**Nick Nelson, Senior Planner**  
**Jefferson County Planning & Zoning**  
**Suite 3550 100 Jefferson County Parkway**  
**Golden CO 80419**

**From:** John Wallack, Pleasant Park Neighborhood Association (PPNA)

**Subject:** Conifer Center Case No. 20-111200RZ Impact on Conifer Ground Water

Figure 4. Single Sub-basin WAA of Conifer Center

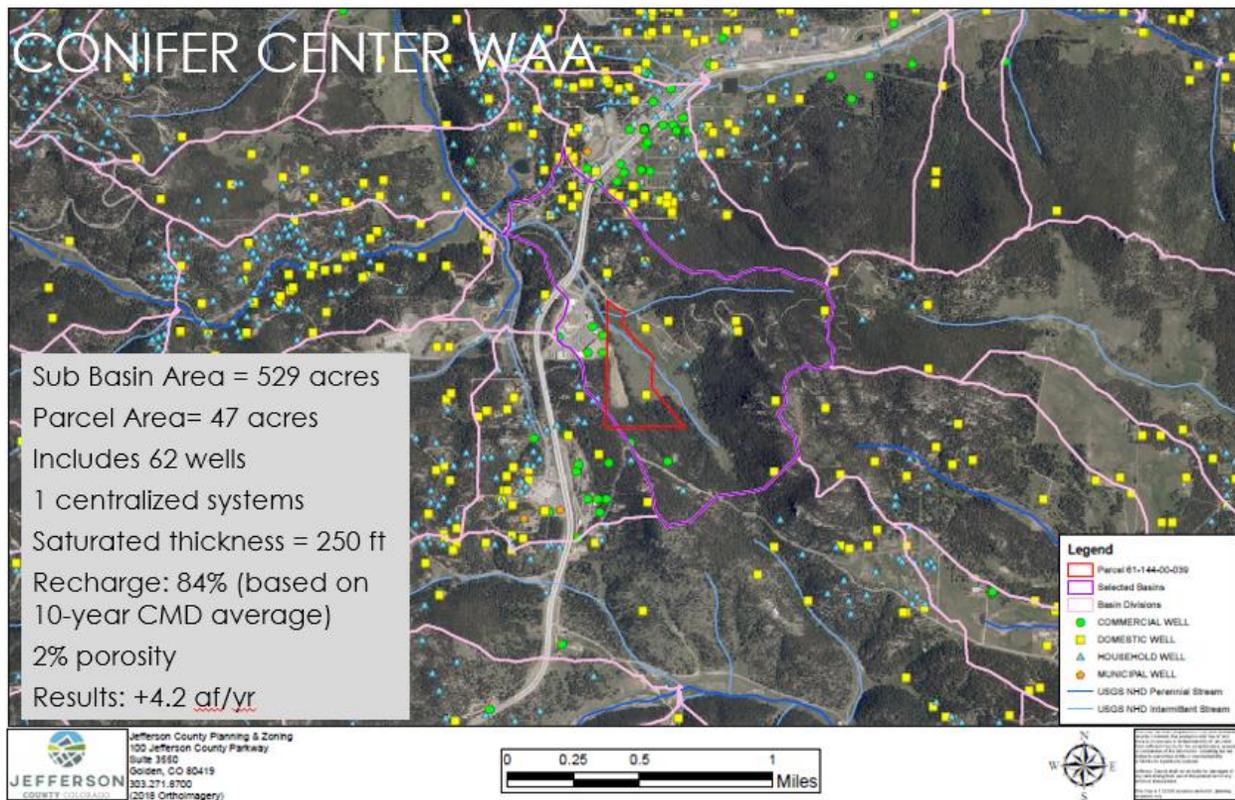
The first WAA is an isolated look at the 47 acre parcel in a single sub-basin (magenta line on Fig.4). The sub-basin selection was recommended by Jeffco and using this single basin enabled matching the well listings.

The result is positive for this single basin view of the development and would not indicate a problem with allocation of only 62 wells in this sub-basin. Six of the wells are monitoring wells, so 56 wells are taken into account over the 529-acre sub-basin. The recharge values are based on a 10-year average (83.6%) for CMD and the 10 water-year summaries are included in the WAA.

Figure 5. WAA of Conifer Activity Center

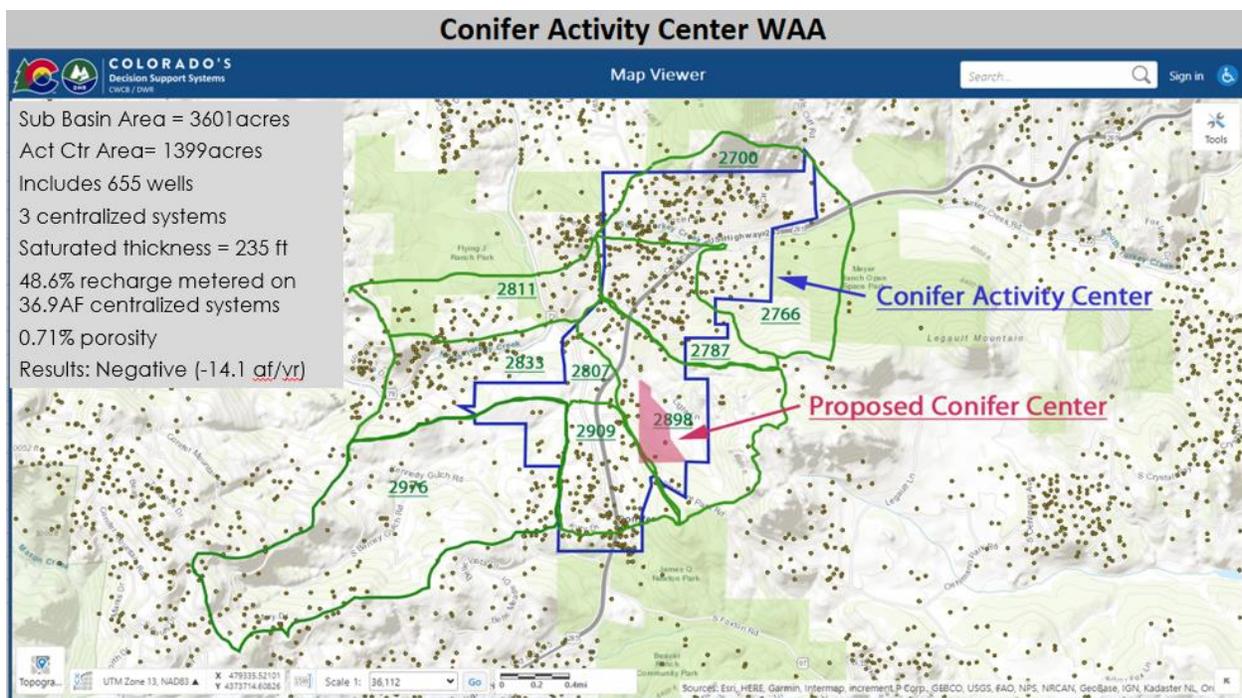
The second WAA was performed on the Conifer Activity Center. By widening the aperture, the affects of all three centralized systems and “release to surface” are considered. The Activity Center is 1399 acres and there are 9 sub-basins that intersect it. Sub-basin 3108 (South of the Activity Center) was not included because it is on the south side of a watershed boundary where the flow is out from Activity Center into Kennedy Gulch and would not provide catchment. The sub-basin area is 3601 acres, including 655 wells and 3 centralized systems. The water year 2020 values for total production and recharge (all 3 systems combined) were used: 36.9 AF and 48.6%.

During the Turkey Creek study, fracture network orientation data from nine localities were collected along natural outcrops in the Turkey Creek watershed.<sup>2</sup> Porosities of rock types were modeled. Table 23 of the study lists mean porosities for the basic rock types in the area. The Bryant geologic map was used to calculate the porosity by rock type and this is included in the WAA.<sup>3</sup> The WAA result was negative (-14.1 af/yr) indicating that ground water may be over-allocated for the Activity Center.

Figure 7. WAA of Conifer Activity Center including adjacent approved Planned Developments.

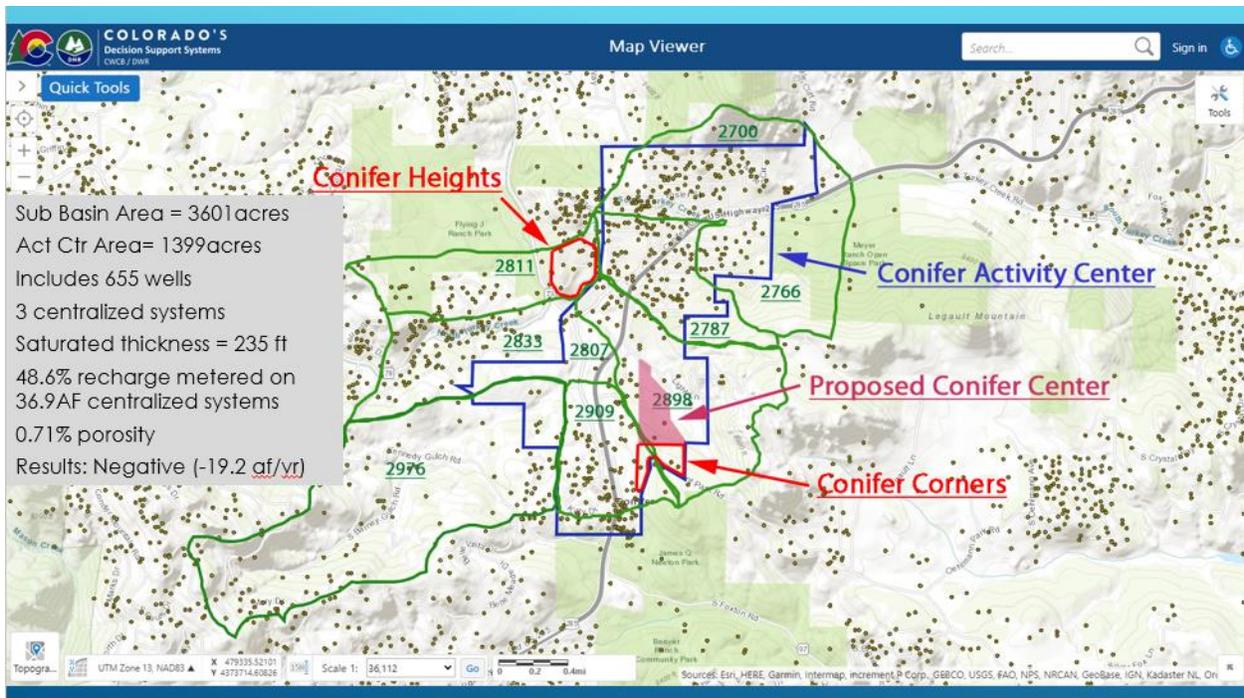
Considering what has already been approved, the total number of dwelling units is 328 for all three developments. The results of this WAA are negative (-19.2 af/yr) again, indicating that ground water may be over-allocated for the Activity Center.
